WBN-TS-03-12

10 CFR 50.90

WATTS BAR NUCLEAR PLANT (WBN) – LICENSE AMENDMENT (WBN-TS-03-12)
MONITORING OF CONTROL OR SHUTDOWN ROD POSITION BY AN ALTERNATE
MEANS

**PROPOSED LICENSE AMENDMENT REQUEST WBN-TS-03-12
DESCRIPTION AND EVALUATION OF THE PROPOSED CHANGE**

Figure 1 – Potential Problem Area Inside Containment

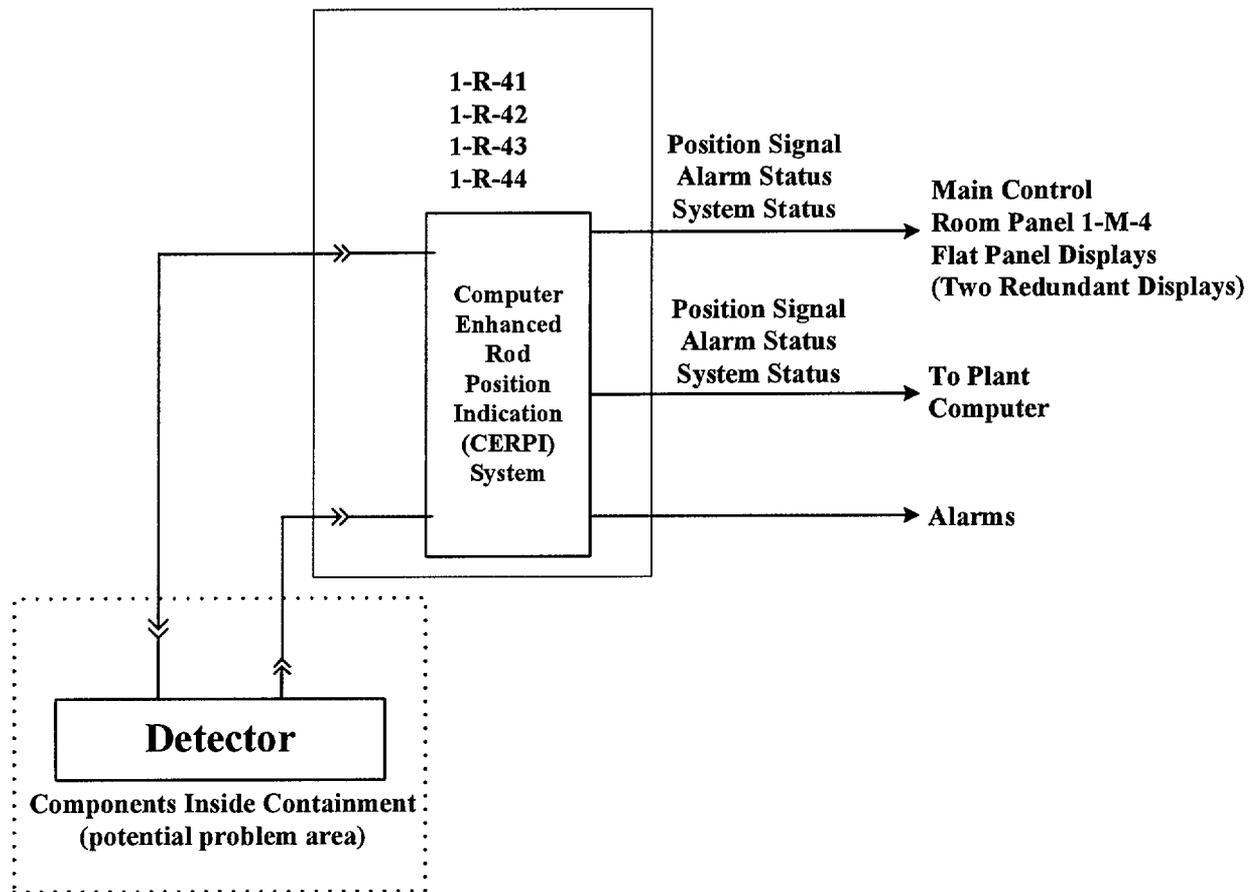
Should a technical problem with ARPI components inside containment arise, no further action can be taken to address the problem as long as Unit 1 is operating. This is due to the adverse radiological and temperature environment that exist in the reactor head area prior to entering Mode 5, Cold Shutdown. Further complicating the repair is the requirement that the Control Rod Drive Mechanism (CRDM) ventilation be operated when the hot leg temperatures are above 180 degrees F. Accessing the reactor head area with the CRDM ventilation operating is dangerous.

In addition, an ARPI coil stack may have to be lifted by a crane to allow access to the connectors. For this to occur the missile shield must be removed and this cannot be performed until the unit was in Mode 5. Shutdown of the unit to Mode 5 just to implement the needed repairs is considered inappropriate since other options for the monitoring of the status of the rod are available.

Figure 2 – Proposed Monitoring of Stationary Gripper Coil

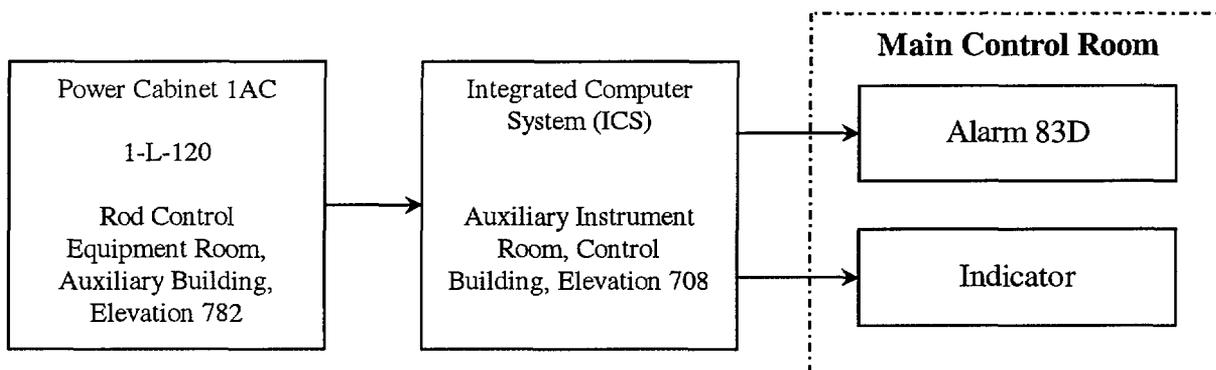
TVA plans to utilize the plant computer to monitor the stationary gripper coil voltage. Monitoring the inoperable ARPI in this manner will allow for historical data retrieval and will also allow the use of the existing rod deviation alarm. The “Rod at Bottom” status light and the “Rods at Bottom” annunciator for the affected control rod may be disabled. A simplified schematic of the monitoring circuit is provided below in Figure 2:

Since the monitoring will be performed by Operations, TVA proposes to continue the monitoring to determine if the coil has changed state on a once-per-shift basis or once every 12 hours. This is consistent with the 12 hour frequency of Surveillance Requirement (SR) 3.1.5.1 for the verification that the positions of the rods are within the alignment limits. Should the parameters of the coil of the monitored rod indicate unintended movement, a determination of the position of the rod will be made using the movable incore detectors. The position of the monitored rod will be established using the movable incore system at least once every 31 days in accordance with proposed action A.2.1.
